MEETING OF THE MINTURN PLANNING COMMISSION Minturn, CO 81645 • (970) 827-5645

Wednesday, July 14, 2021 Regular Session – 6:30 PM

Hearing Date:	July 14, 2021
File Name and Process:	Faircloth Garage Addition / Variance Request
Owner/Applicant:	Heather Faircloth
Representative:	Tom Warzecha
Legal Description:	BOOCO Subdivision, Block F, Lot 12 and Part of Lot 13
Address:	261 Main Street
Zoning:	Old Town Mixed-Use (Old Town Character Area)
Staff Member:	Scot Hunn, Planning Director Madison Harris, Planner I
Recommendation:	Approval, with Conditions

Hearing Date:	July 14, 2021
File Name and Process:	Single-Family Residence Final Plan Review
Owner/Applicant:	Emily and Steve Hutton
Representative:	Michael Pukas, MPP Design Shop, Inc.
Legal Description:	Lot 14, Block 2, Booco's 2 nd Addition to Minturn
Address:	482 Eagle River Street
Zoning:	Old Town Character Area – Mixed Use Zone District
Staff Member:	Scot Hunn, Planning Director Madison Harris, Planner I
Recommendation:	Approval, with Conditions

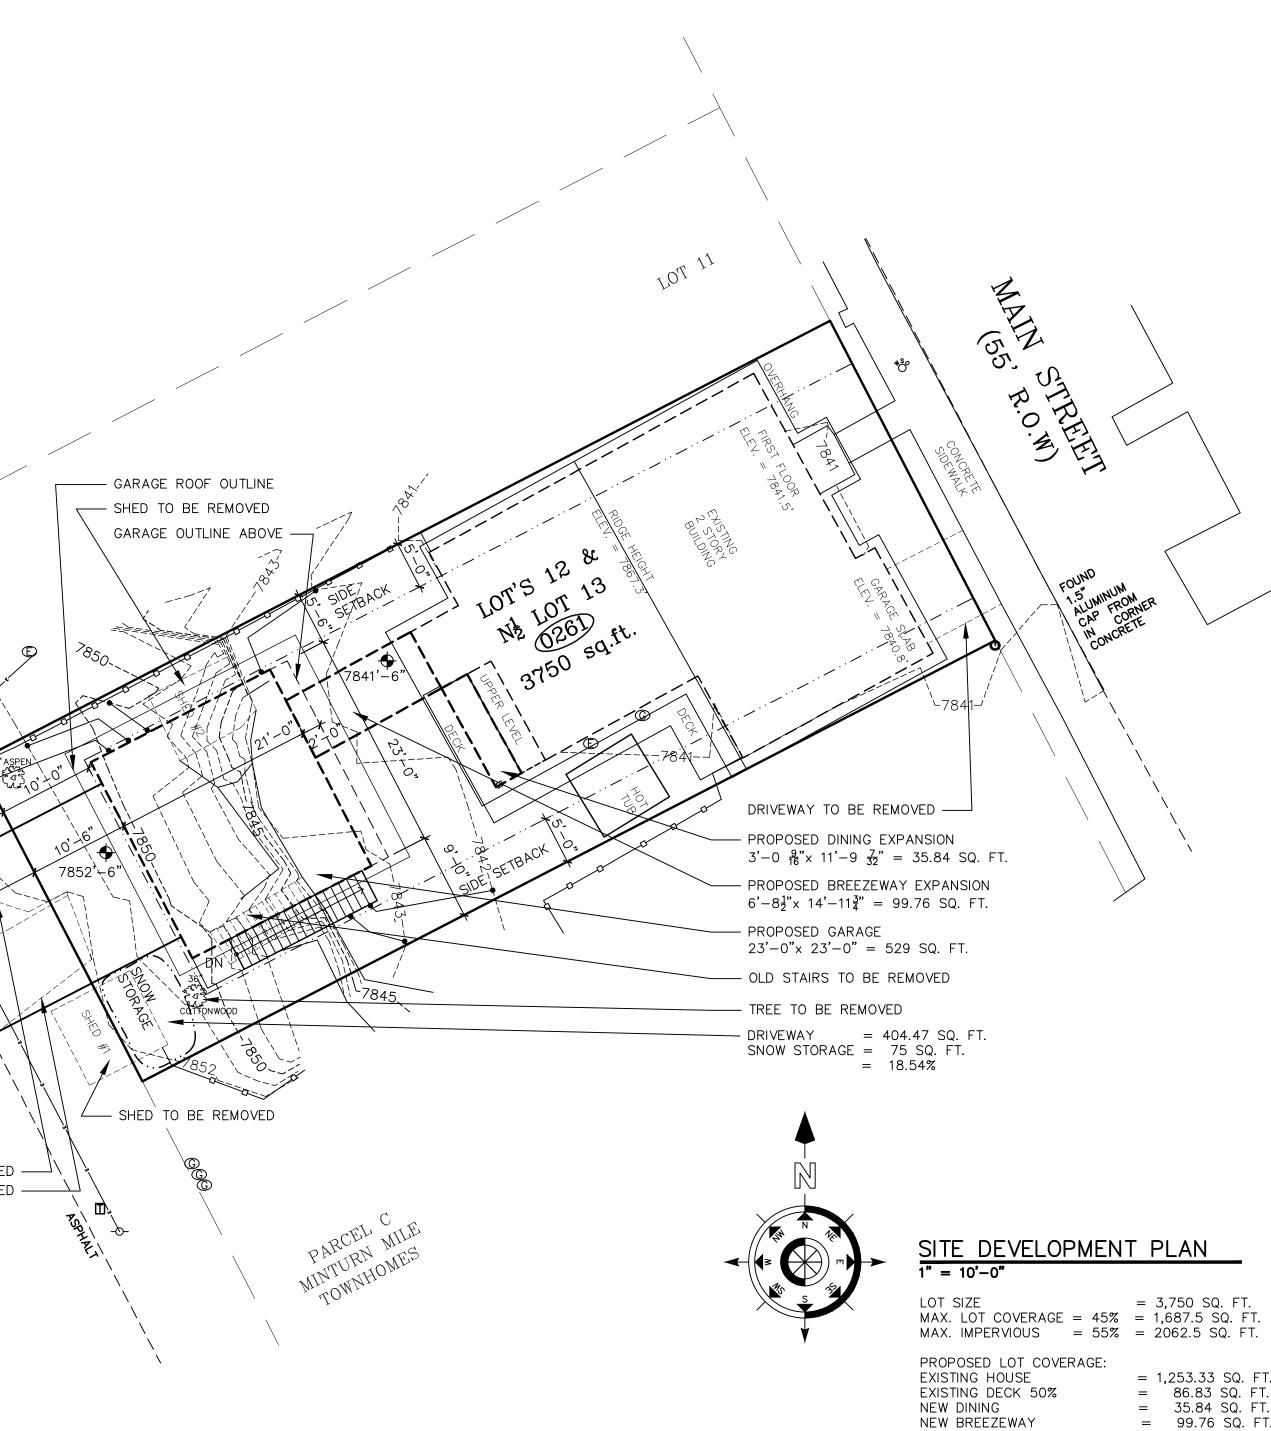
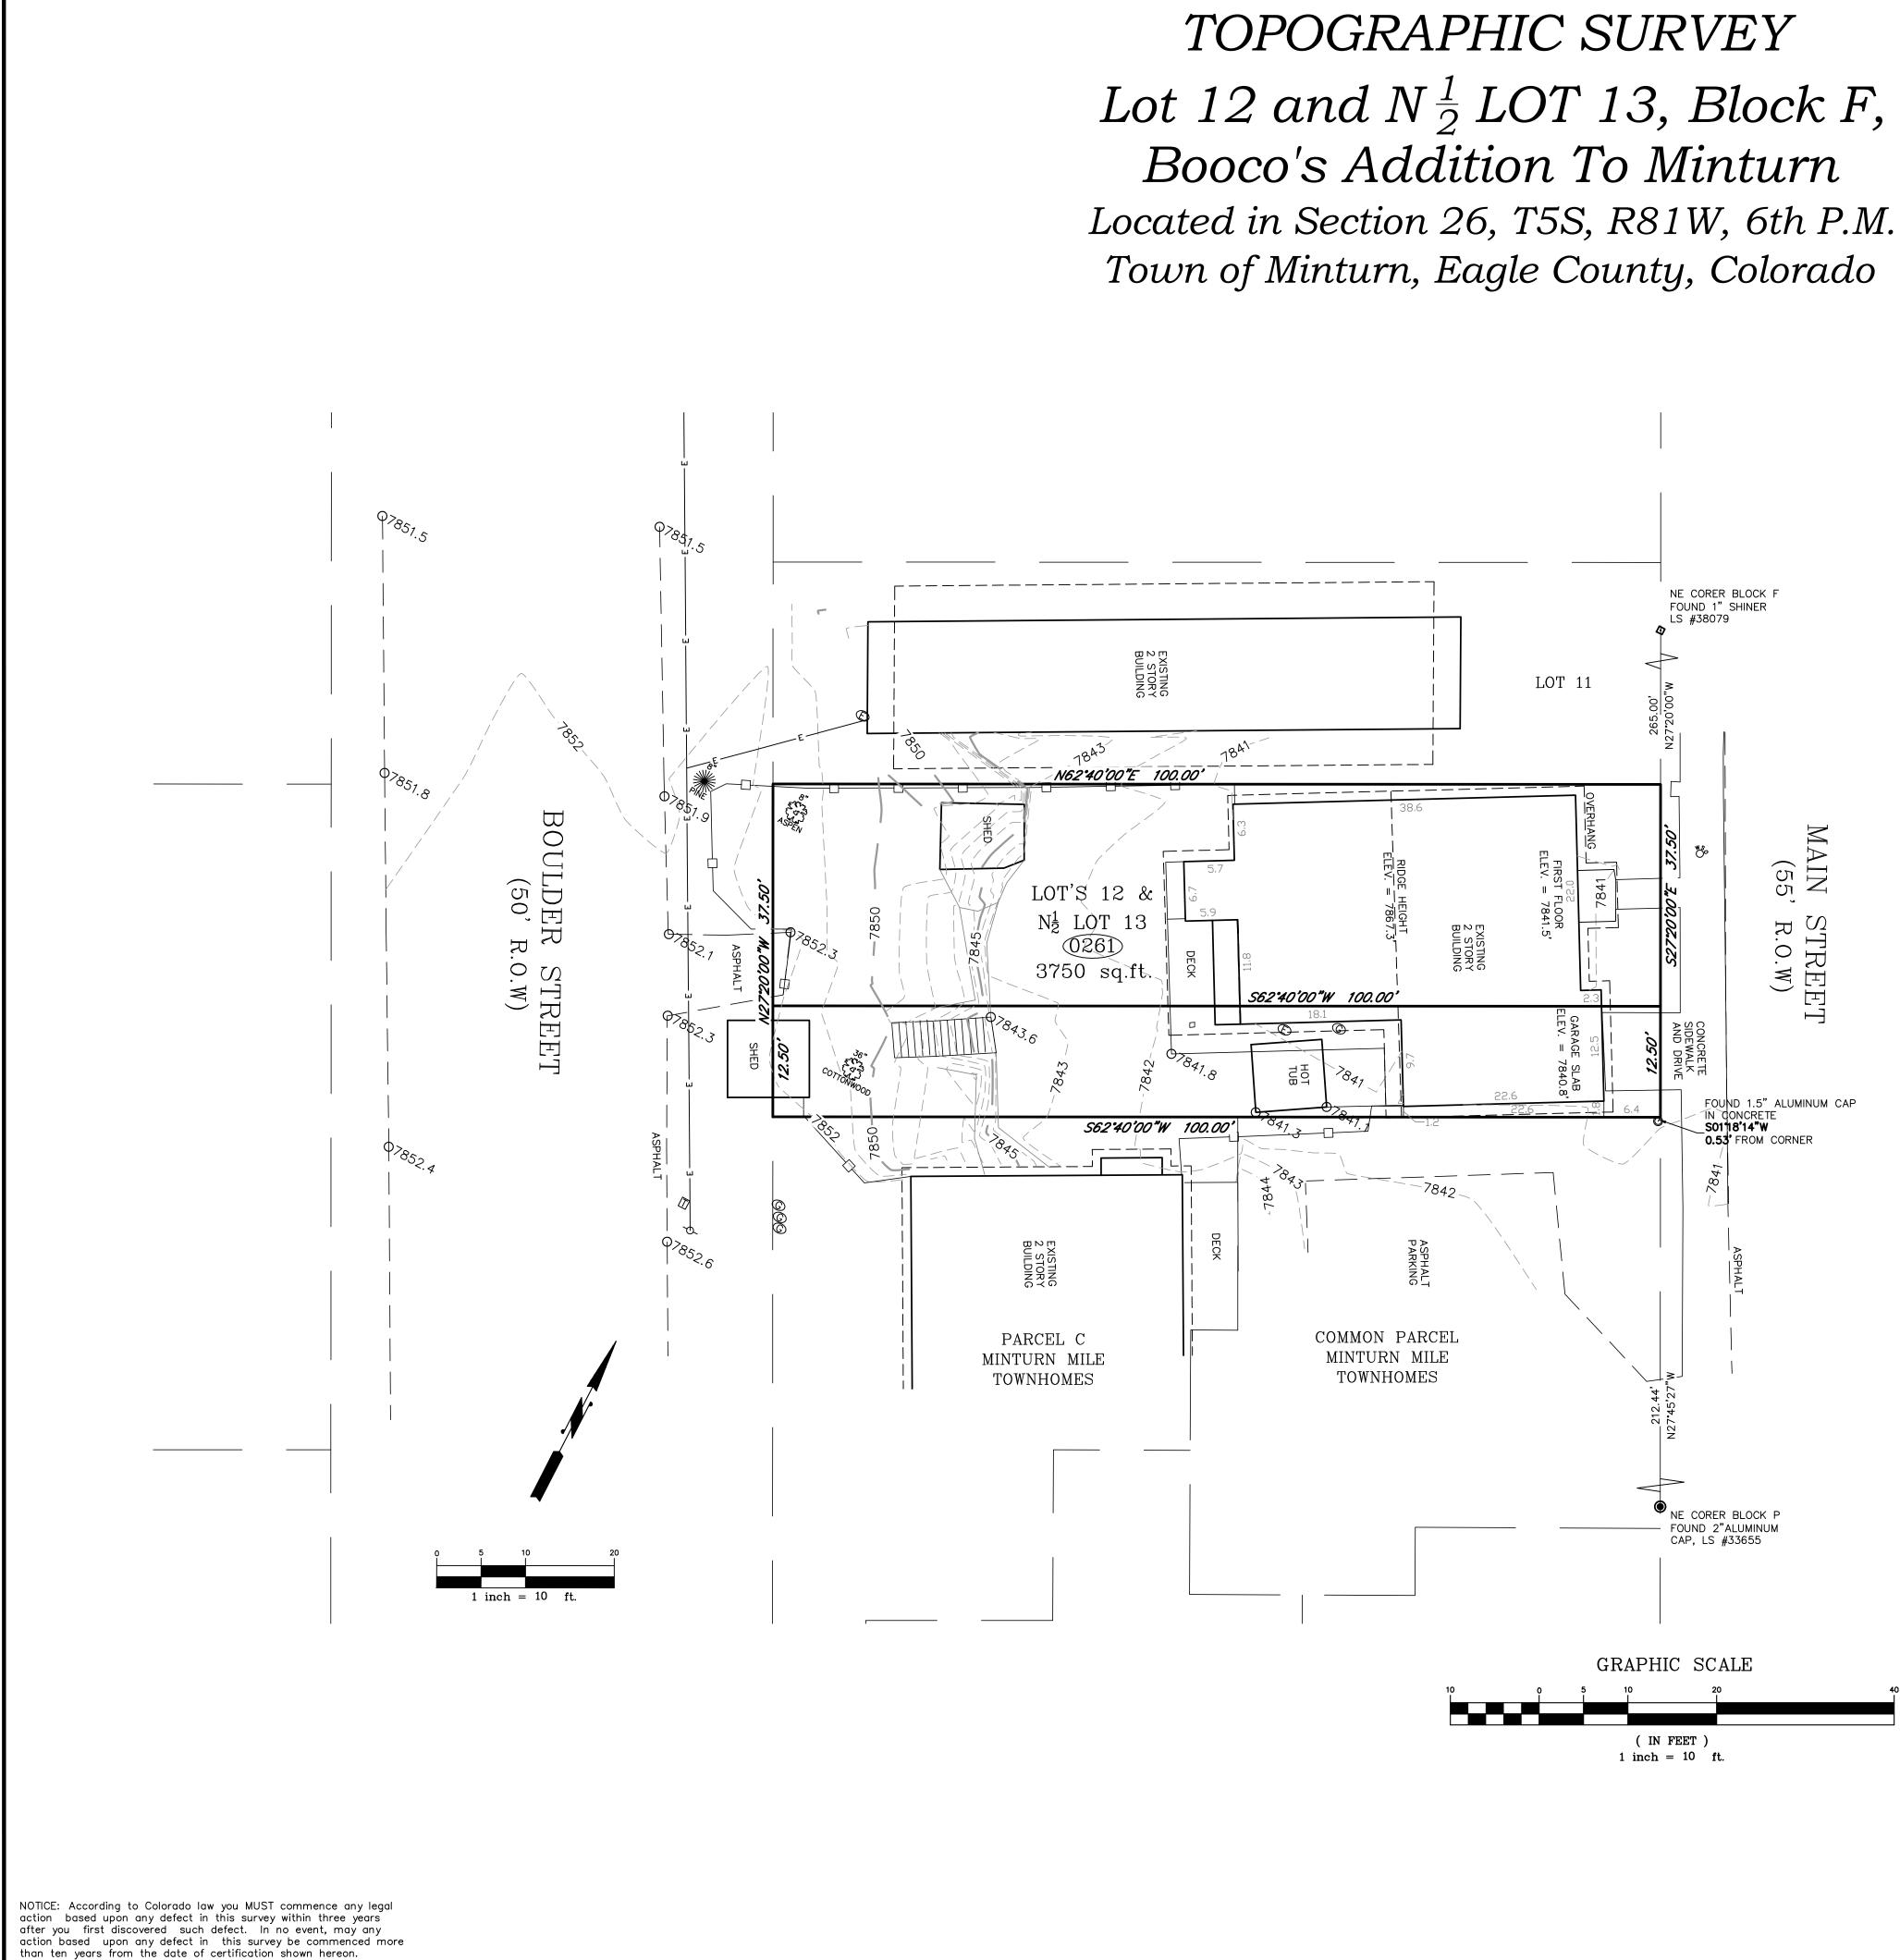
That said, the Applicant is not asking for the minimum amount of relief from the strict application of the regulations, another criteria for consideration of any variance request. Staff respectfully suggests that the plans could be modified to reduce coverage and by eliminating the breezeway. By staff's calculations, removal of the breezeway would reduce the total lot and impervious coverage by approximately 3.7%, bringing the total at or below 60%.

Staff is recommending approval of this request with the condition that the breezeway be removed from the plans to reduce the overall, or total lot coverage and impervious coverage to no more than 60%, allowing for a total variance from the Town's standards of no more than 5%.

- 1. The Applicant shall provide final grading and drainage details, including an updated survey showing spot elevations, for review by the Town Planner and Engineer prior to the submittal for building permit.
- 2. The Applicant shall revise the site and/or floor plans to show all proposed exterior light locations and provide final cut sheets/specifications for proposed exterior light fixtures prior to or concurrent with building permit applications to ensure compliance with the Town's lighting standards as well as consistency with fixtures found on the existing residential structure on the subject property.
- 3. The Applicant shall revise the Final Plans to remove the breezeway and/or revise other aspects of the plan to reduce overall, total impervious surface coverage to no more than 60%.
- 4. The Applicant shall provide final details and dimensions for all proposed exterior
